Subject: Special Service Campaign (SSC) 7LB (Safety Recall)
Lexus ES 350 All Weather Floor Mat Accessory for 2007 and Early 2008 Model Year Vehicles

Special Service Campaign (SSC) – 7LB (Safety Recall) Q&A

**SSC 7LB – LEXUS ES 350 ALL WEATHER FLOOR MAT ACCESSORY SAFETY RECALL NOTICE
FOR 2007 AND EARLY 2008 MODEL YEAR VEHICLES**

**Lexus ES 350 All Weather Floor Mat
Involved in this recall**

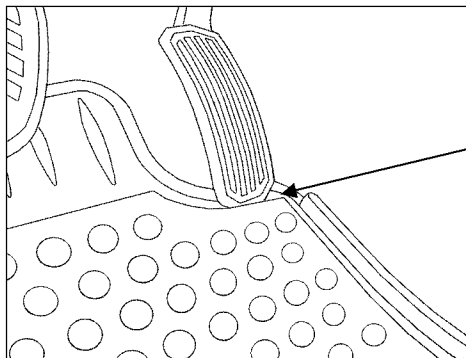
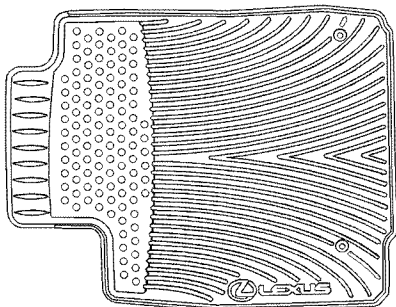
The optional Lexus ES 350 All Weather Floor Mat includes two grommet holes in the All Weather Floor Mat and retaining hooks (clips) to secure the mat to the vehicle's carpet. Lexus has received reports that if the optional Lexus ES 350 All Weather Floor Mat (either by itself or if it is placed on top of an existing carpeted floor mat) is not secured by the retaining hooks (clips), the mat can move forward and interfere with the accelerator pedal returning to the idle position.. ***If the mat is properly secured, it will not interfere with the accelerator pedal.***

If the Lexus ES 350 All Weather Floor Mat is not **secured by the retaining hooks (clips)** and the mat moves forward, it may interfere with the accelerator

**Lexus ES 350 All Weather Floor Mat
Involved in this recall**

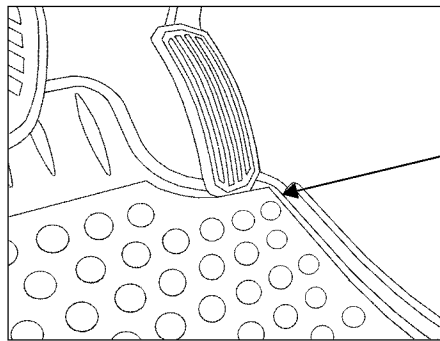
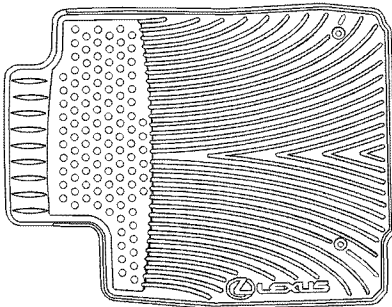
If the Lexus ES 350 All Weather Floor Mat is not secured by the retaining hooks (clips) and the mat moves forward, it may interfere with the accelerator pedal.

SSC	Opcode	Description	Flat Rate Time
7LB	7519J1	Replace the affected original driver's side All Weather Floor Mat with the newly designed All Weather Floor Mat	0.2
